1CAN081504

Subject: ANO-1 Cycle 26 COLR
Arkansas Nuclear One - Unit 1
Docket No. 50-313
License No. DPR-51

ANO-1 Cycle 26 Core Operating Limits Report (COLR)

CORE OPERATING LIMITS REPORT

Figure 11**Reactor Protection System Variable Low Pressure Temperature Envelope Setpoints**

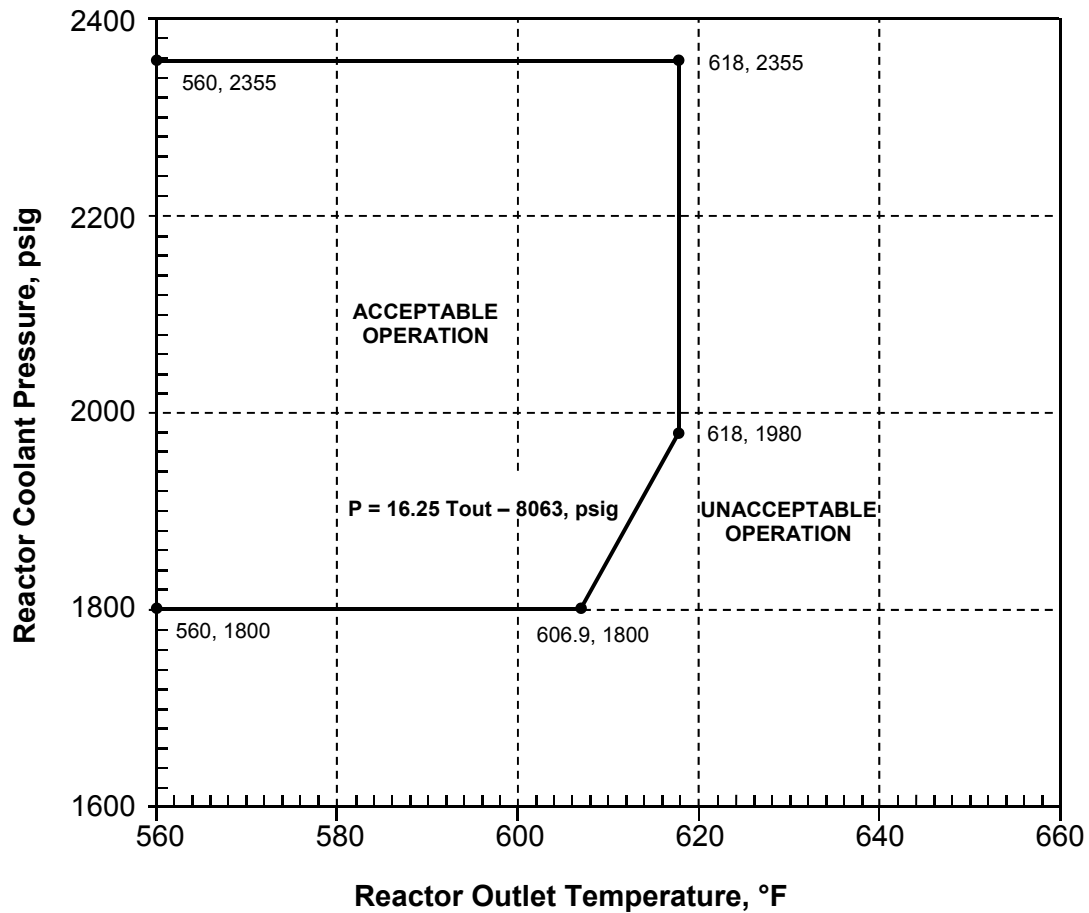
Entergy Operations, Inc. (Entergy) Arkansas Nuclear One, Unit 1 (ANO-1) Technical Specification 5.6.5 requires the submittal of the Core Operating Limits Report (COLR) for each reload cycle. Revision 0 of the ANO-1 Cycle 26 COLR was submitted on February 5, 2015 (1CAN021501, ML15036A249). It was recently identified that the axis and some (x,y) coordinates on Figure 11 did not properly convert from Microsoft Word to Adobe and were subsequently missing from the figure (Condition Report CR-ANO-1-2015-3186). Therefore, Revision 0 of the ANO-1 Cycle 26 COLR is resubmitted to include the missing coordinate references. Note that the graph itself did not change from that of the Cycle 25 ANO-1 COLR.
